# Car Stereo Service Bulletin

**Model:** CDX-R77/79

**No.** 157 R1

**Subject:** If Customer Complains Of Distortion **Date:** April 10, 1990

**MAIN BOARD CIRCUIT & PATTERN**

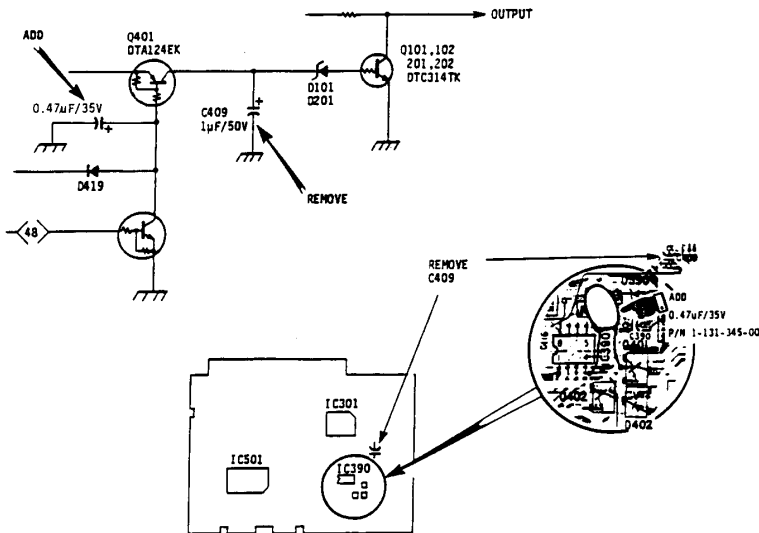
**Symptom:**  
(53)

When measuring distortion, the reading will initially be very high as player begins playing a track.

**Solution:** Remove Capacitor C409, and install a .47 $\mu$ F/35V Tantalum Capacitor (Part Number 1-131-345-00) from Pin 4 of IC390 to the base of Q401. Please note proper polarity.
